Alpha HPA Response to Information Request Special Industry and Linear Infrastructure Facility

We write on behalf of Alpha HPA (the Applicant) in response to the information request issued on 15 August 2024 requesting further information on the Amended State Development Area Approval for Special Industry and Linear Infrastructure Facility at 53 Reid Road, Yarwun.

QRA ADDENDUM UPDATED INVENTORIES

Figure 2.1: Site layout

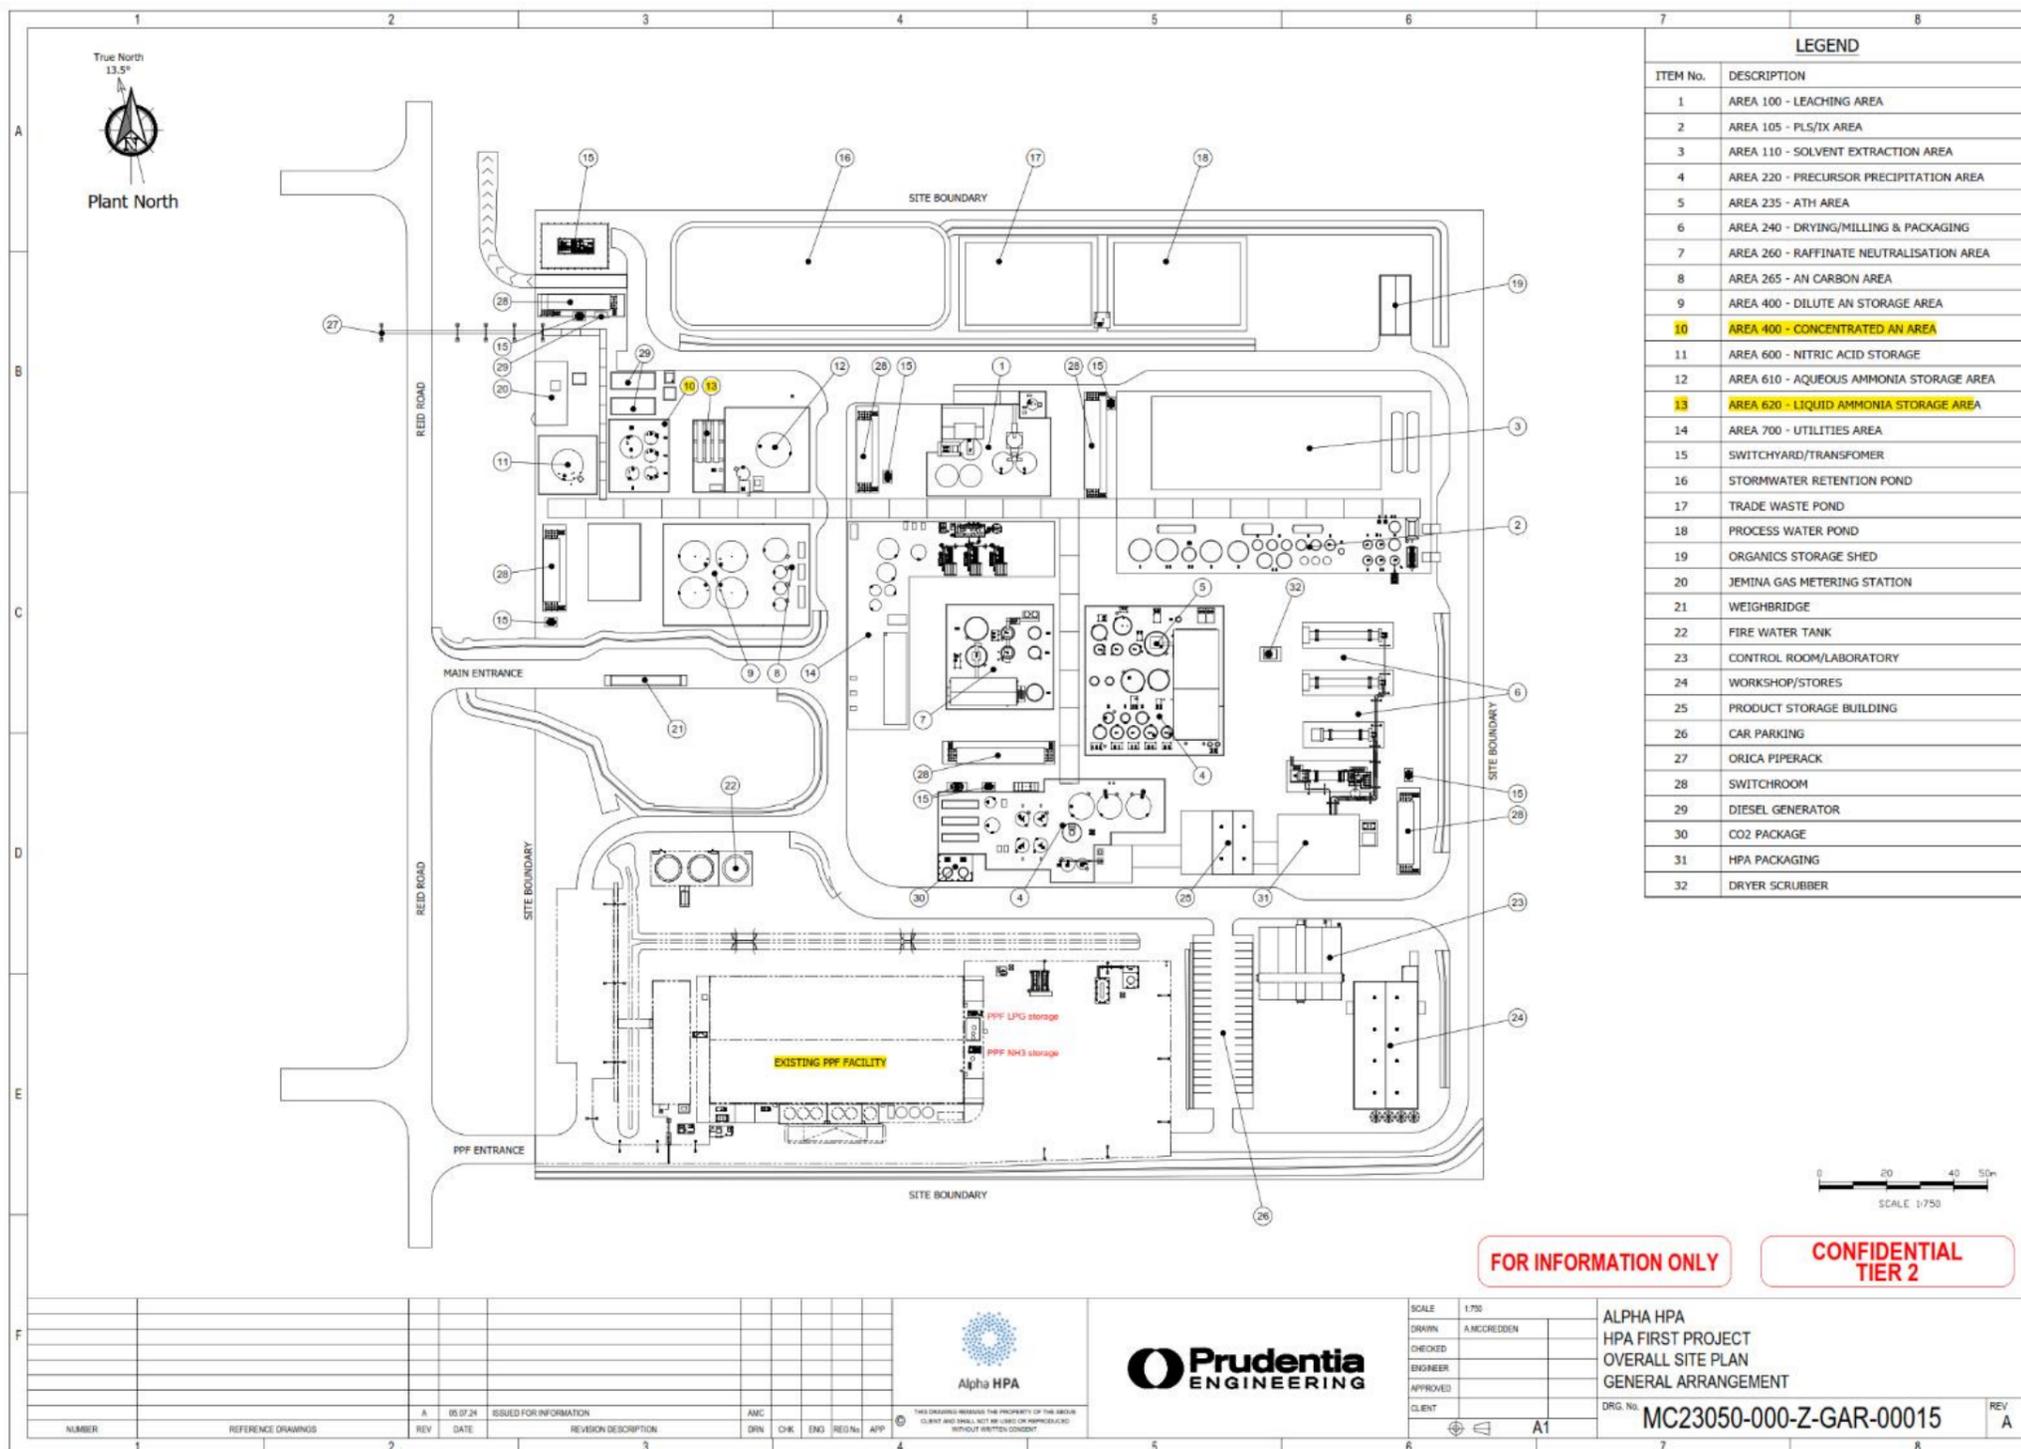
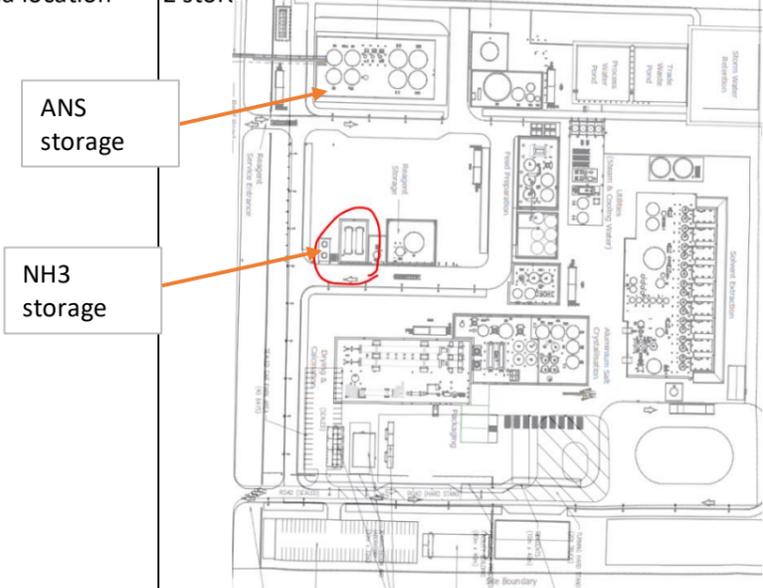
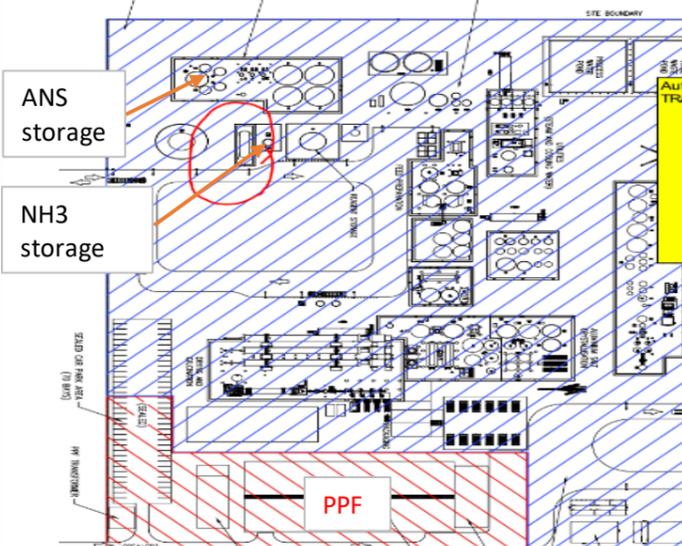
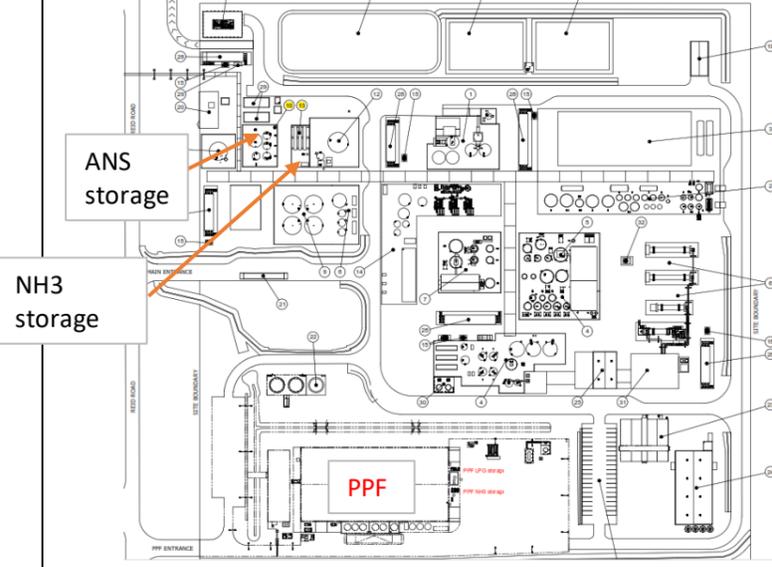
Some changes have been made to the Stage 2 layout and inventories as detailed design has progressed. Figure 2.1 shows the updated site layout. Changes in stage 2 layout accounted for in the QRA are:

- Concentrated ammonium nitrate solution (ANS) has moved slightly south.
- Anhydrous ammonia storage has moved slightly south.
- Solvent extraction process area bund has been reoriented.

Figure 3.1: Overall cumulative individual fatality risk

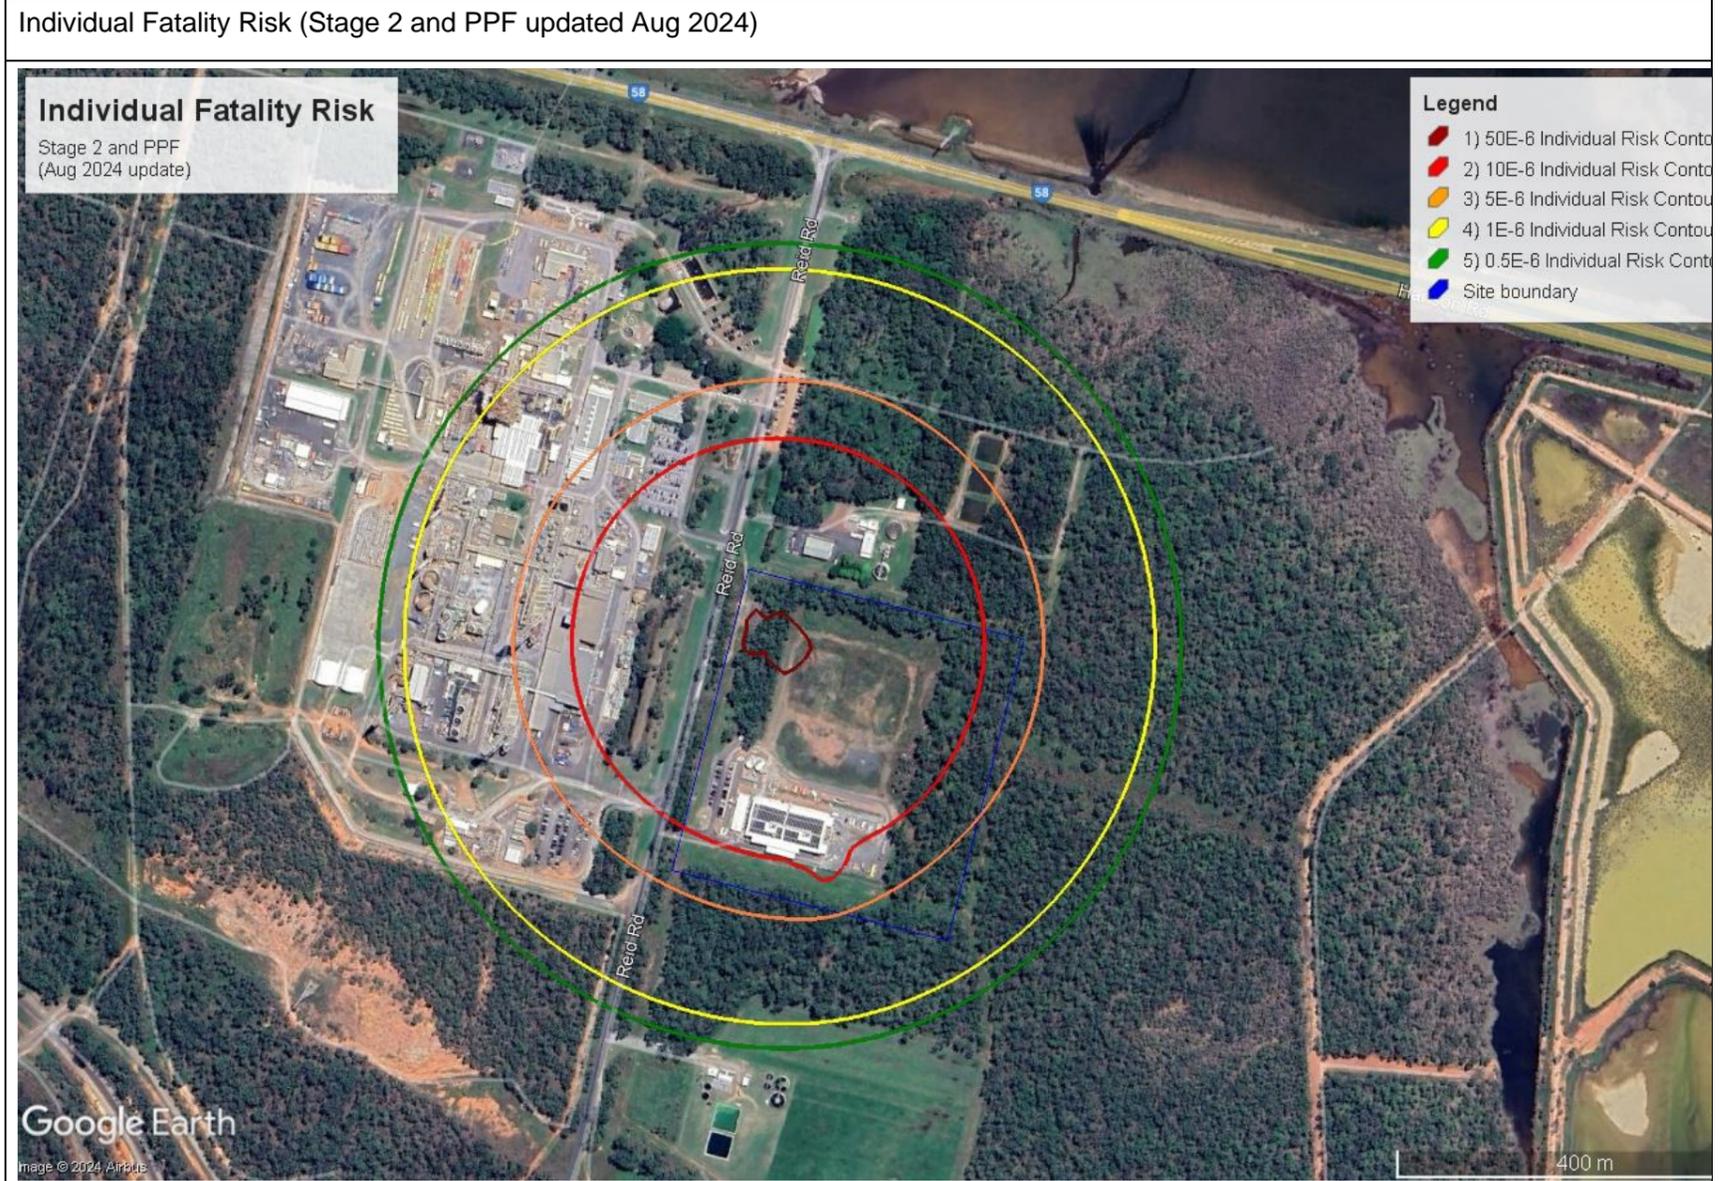
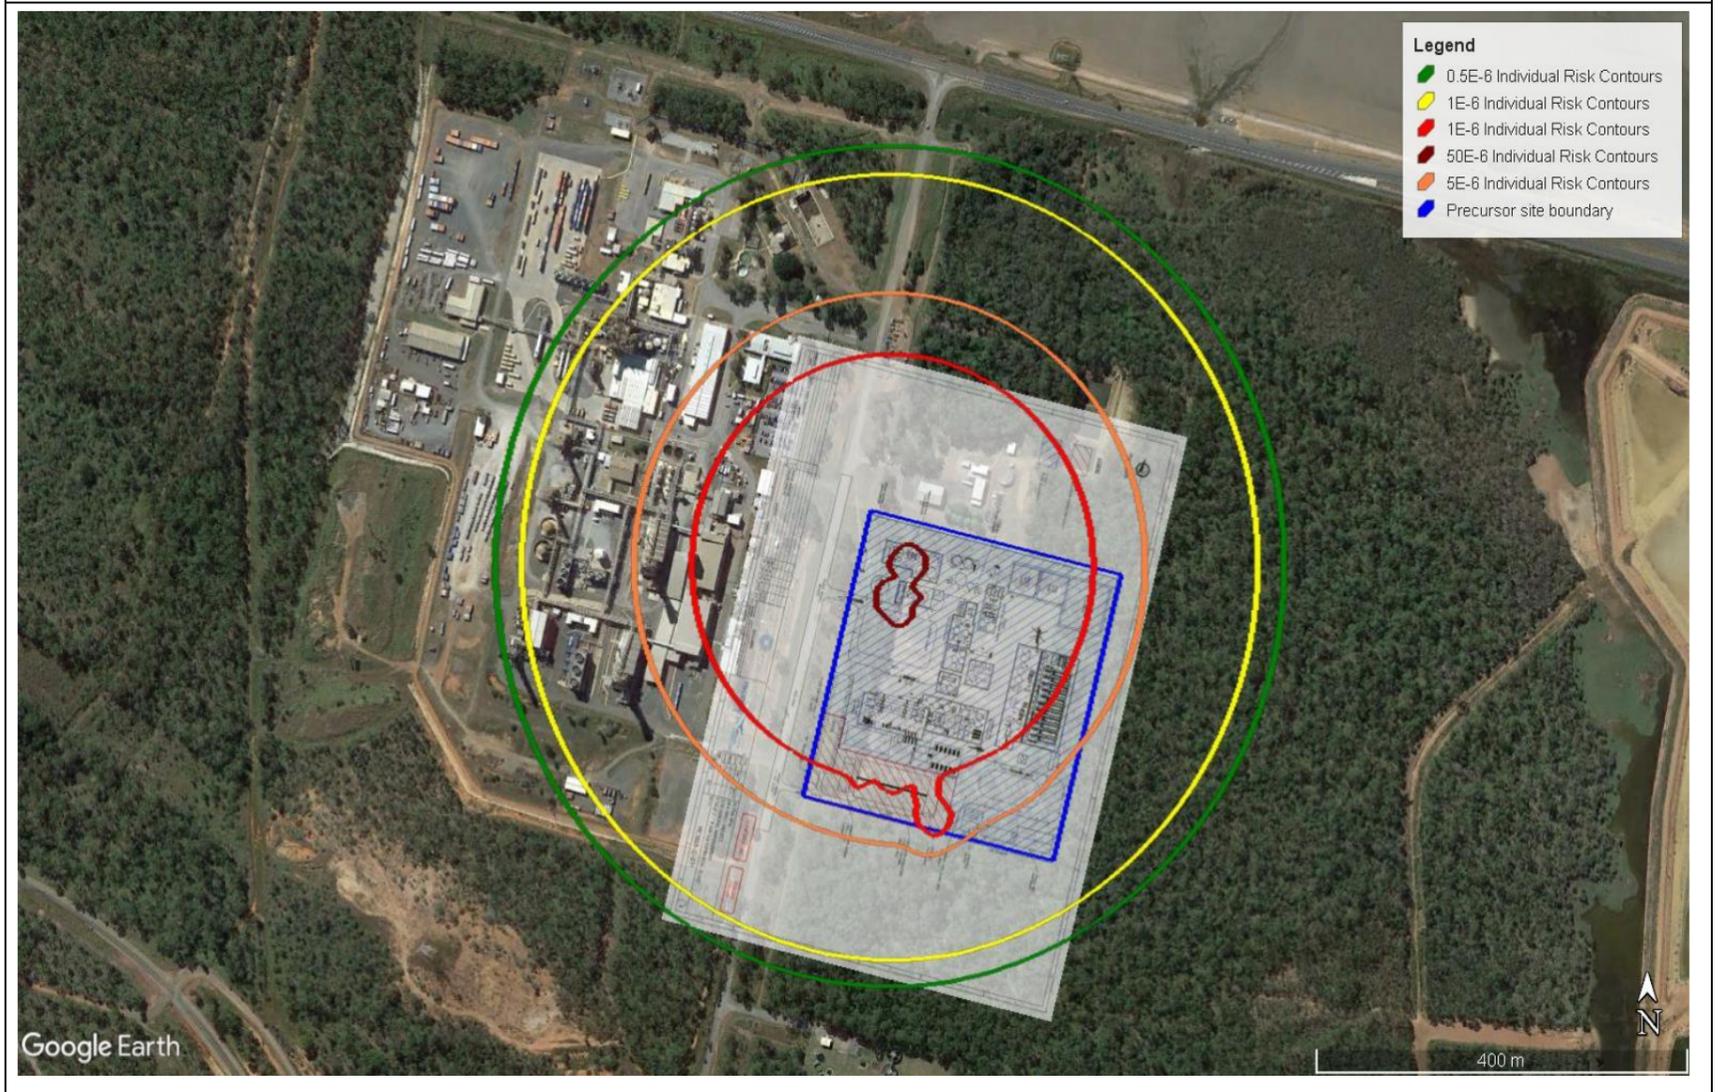
The individual fatality risk results for the overall site including the PPF and Stage 2 are shown in Figure 3.1 and also compared to the previous risk results (Ref [2]).

There is minimal difference to the previous risk results and all criteria in State Code 21 v2.6 are met. .

Figure 3.2: Cumulative societal risk results (Stage 2 and PPF updated Aug 2024)

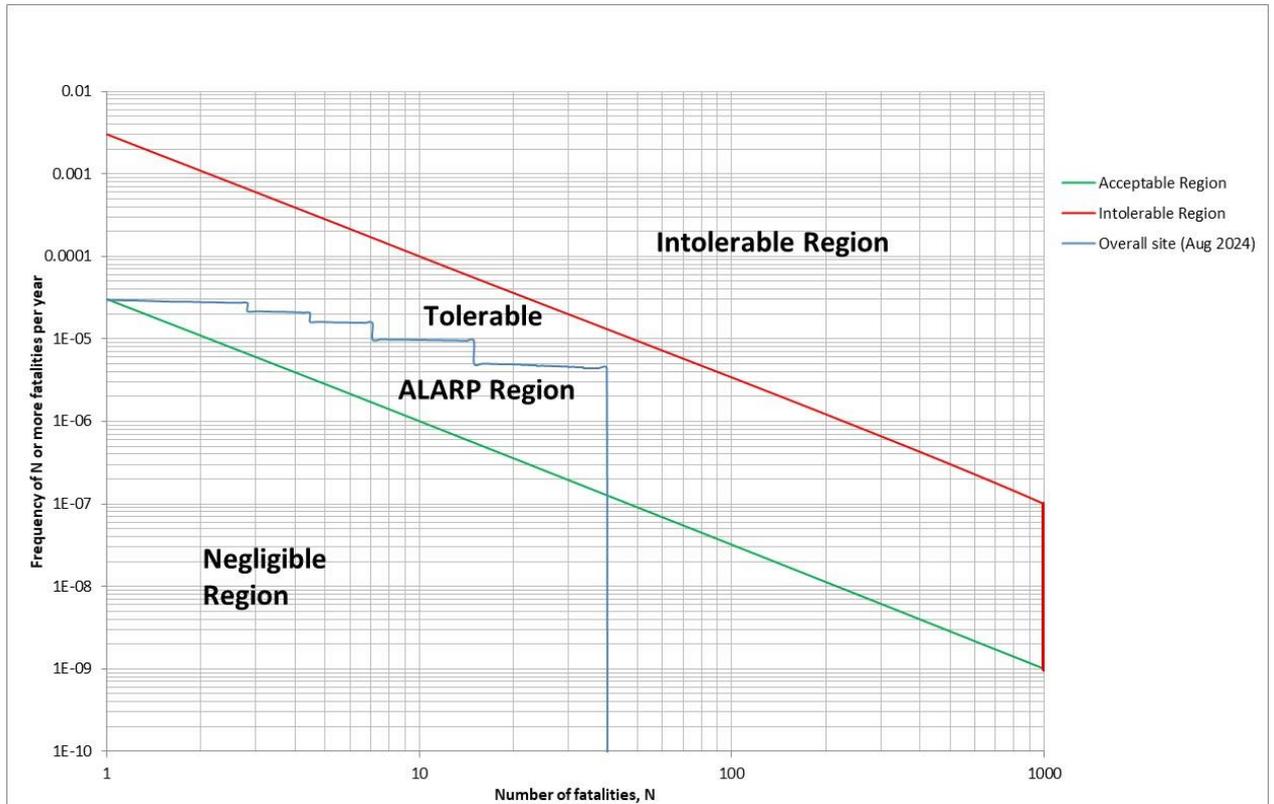
The societal risk results for the overall site including the PPF and Stage 2 is shown in Figure 3.2. The FN curve is fully within the tolerable/ ALARP region or negligible region and does not extend into the intolerable region. There is no material change from the results presented in the previous QRA.
